N1996A-01C

S E R V I C E N O T E

Agilent CSA Spectrum Analyzer, N1996A

Residual Responses due to Shield Problem on A4 Digital IF Assembly

Figure 1: Marker Reading Peak Residual Level

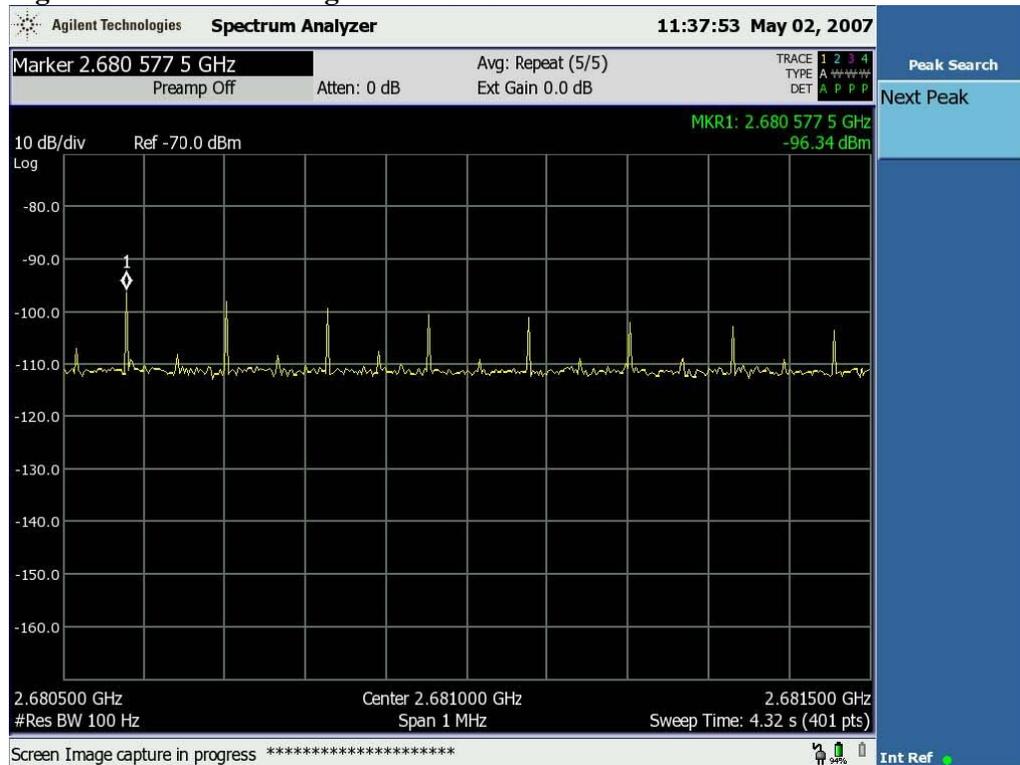
- 1 Terminate the analyzer input with a 50 Ohm load.
- 2 Press **Mode, Spectrum Analyzer**.
- 3 Press **Mode Preset**.
- 4 Press **FREQ, Center Freq, 2681 MHz**
- 5 Press **SPAN, 1 MHz**
- 6 Press **AMPTD, Ref Level, -70 dBm**.
- 7 Press **BW, Res BW, 100 Hz**.
- 8 Press **Meas Setup, Avg Mode, Repeat**
- 9 Press **Avg Number, 5, Enter**
- 10 Press **Trace/Detector, Average**
- 11 Press **Single**. Wait until the message “Paused. Press Continuous or Single to Continue” appears on the status line at the bottom of the display.
- 12 Press **Peak Search**. The marker amplitude reading represents the level of the highest residual response. See Figure 1. Record this marker amplitude value in Table 1 in the Peak Residual Level column of the “As Received” row.
- 13 If the Peak Residual Level is above -100.0 dBm, the residual responses are too high. Proceed with Solution/Action.

Step 1

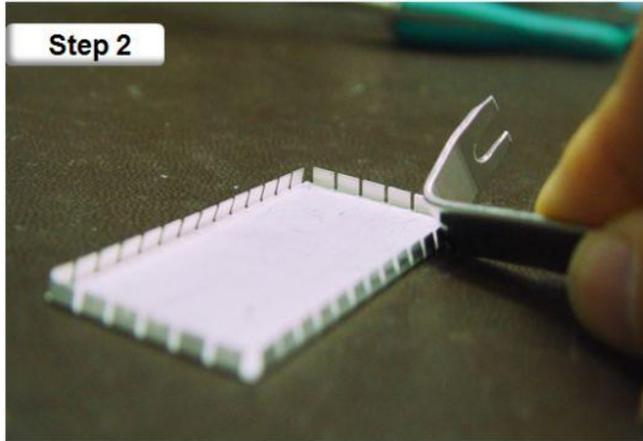
Step 1 & Step 2:*(The most important and compulsory Step)*

After removed the shield covers, use the “L-shape connector opener or any hard tool to slightly bend (around 6° from vertical) the fingers of the shield covers.

Repeat step 1&2 on remaining 3 sides of the shield cover. This step is critical in eliminating the DIF spurs. Any missing of this step would resolve the same scenario again.

Step 3:

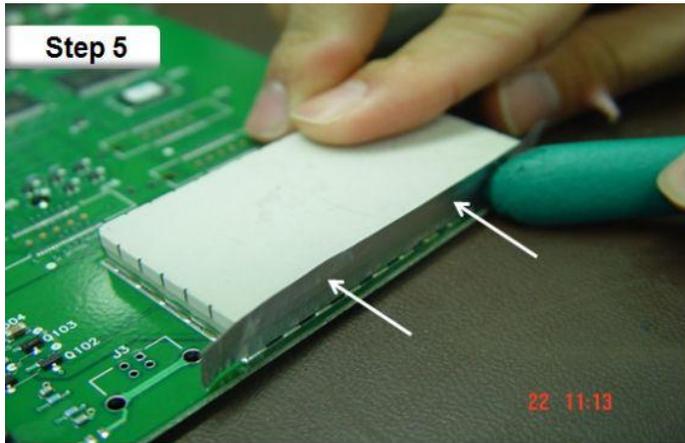
Push and press it at each corner.

Step 13:

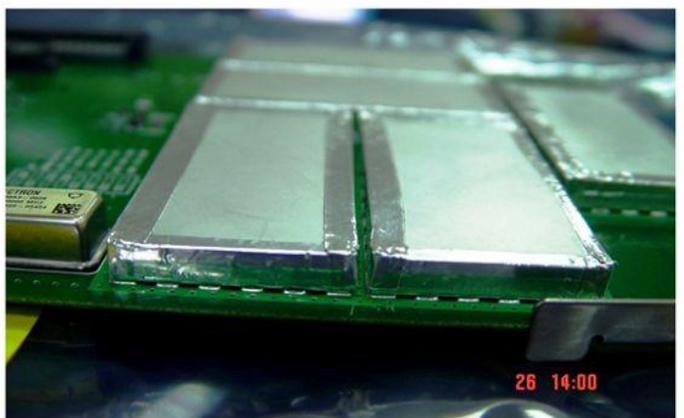
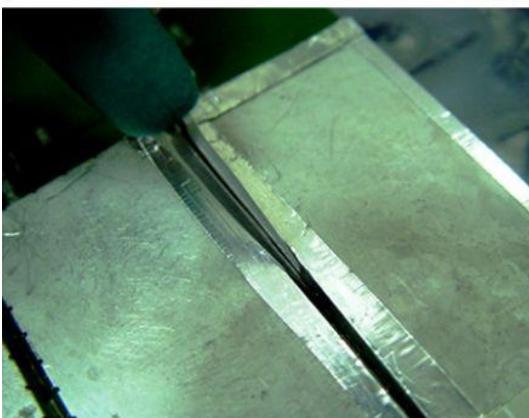
Use the tweezers or any tool to flatten the aluminum foil which is pasted inner of the shield case.
